CRAFTSMAN INFORMATION

No. 01
August 1998

MODEL(s) Craftsman 989.795040 and 989.796060

SUBJECT Additions / Corrections to Illustrated Parts List within Operator's Manuals

3. Craftsman Operator's Manual, Trimmer/Brushcutter Model 989.795040, PN 211862-01, Page 18

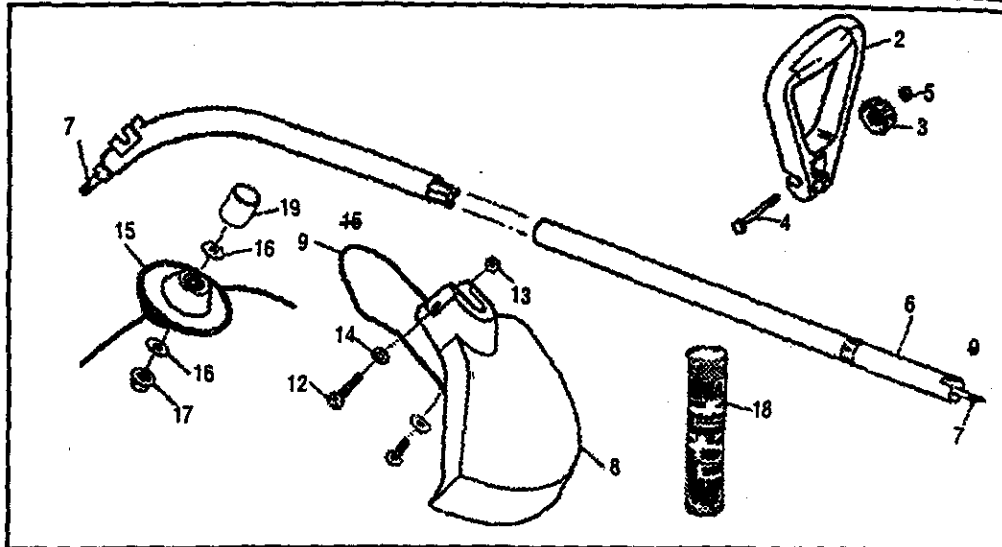
Changes to Part No. List on page 18:

ITEM	CHANGE PN	TO READ	CHANGE DESCRIPTION	TO READ
14	218075-01	218075	no change	Flange, Spindle
22	302554-01	300737	no change	Kit, Knob Asy, Left

**5. Craftsman Operator's Manual, Trimmer Model 989.796060,
PN 211864-01, Pages 14 and 15**

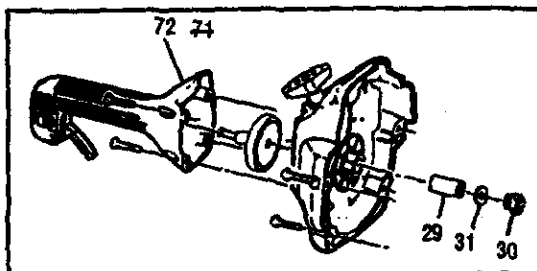
Change to illustration on page 14: Change item 71 pointing at Starter/Clutch Housing to read item 72.

Add to Powerhead Part No. List on page 15:

ADD ITEM	PART No.	ADD DESCRIPTION	REASON
72	See Below	Starter/Clutch Hsg (Qty 1)	New Item No. 72, was inadvertently omitted from original parts list
